Council assessment of Clause 4.6 request

1 Visual representation of height offset

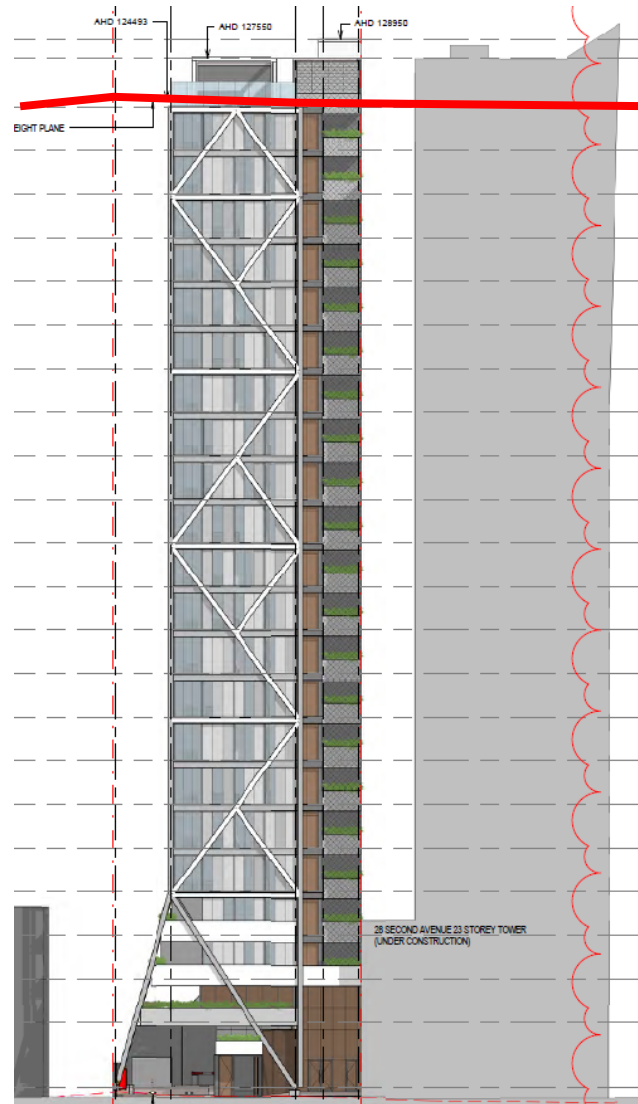
The following figure identifies the portion of the development that exceeds the height of buildings limit. The proposed development is shown on the left. The development currently under construction on the adjoining site to the west (28 Second Avenue) is shown on the right.

The maximum height limit on the site is 72 metres. Although the development exceeds the permissible height by 4 metres for plant and equipment elements only, the development does not achieve an additional residential level. The increase in height therefore does not impact on the density/floor area of the development. The increased height also has no impact on the scale of the development, as the point encroachments of plant and equipment are integrated into the overall design of the building.

The additional shadow impacts are negligible. The majority of the overshadowing caused by the non-compliance is due to the lift overrun and rooftop plant and equipment, which is captured within the roof space itself.

Based on the above assessment, the requested variation under clause 4.6 is considered reasonable, well founded and is recommended for support.
